PATENT NO. 2,300,818  
ISSUED: April 13<sup>th</sup> 2004  
FILED: August 31<sup>st</sup> 1999  
PRIORITY: September 15<sup>th</sup> 1998  
FOR: ROTARY MOWER CONDITIONER HAVING IMPROVED  
CUT CROP FLOW  
OWNER: HAY & FORAGE INDUSTRIES

**REMARKS OF REQUESTER ON RE-EXAMINATION OF A PATENT UNDER  
SECTION 48.1(1) OF THE PATENT ACT**

FIG. A

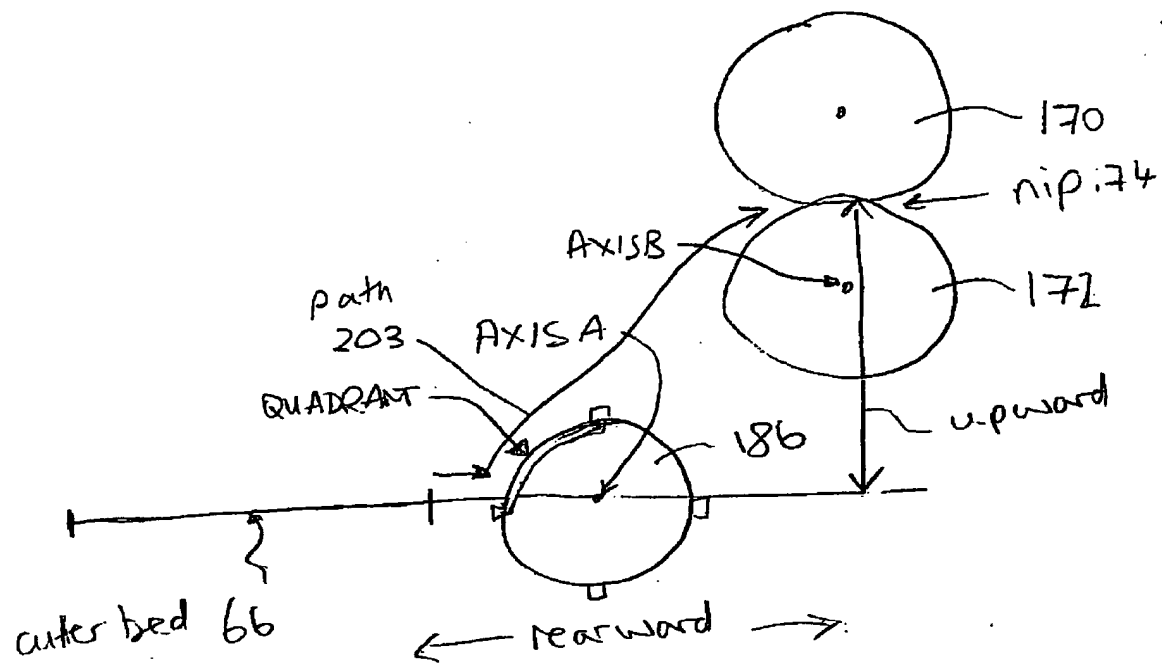
Turning therefore to a proper analysis of exactly what is disclosed in the description, reference is made to the attached Figure A which has been developed with reference only to the description.

These sentences merely state that the axis, indicated in Figure A at axis A, of the roller 186 is below axis B of the roller 172. The second sentence defines an upper front quadrant marked on Figure A of the roller 186 and states that it presents an upwardly and rearwardly moving surface extending between the cutter bed 66 and the nip 174. This quadrant is marked at "quadrant" in Figure A and it is shown generally extending between the cutter bed 66 and the nip 174.

These conditions are marked on figure A by the path or arrow 203.

It will be noted therefore that the description is entirely silent as to the height of the bottom conditioning roll 172 relative to the guide roller 186 and in relation to the position of the quadrant of the roller 186 relative to any part of the bottom

conditioning roller 172. Thus the arrangement illustrated in Figure A attached hereto is entirely consistent with the complete description of the patent.

There is no support in the description therefore for the above quoted limitation that the quadrant is in front of the lower forward peripheral portion of the lower conditioning roller 172.
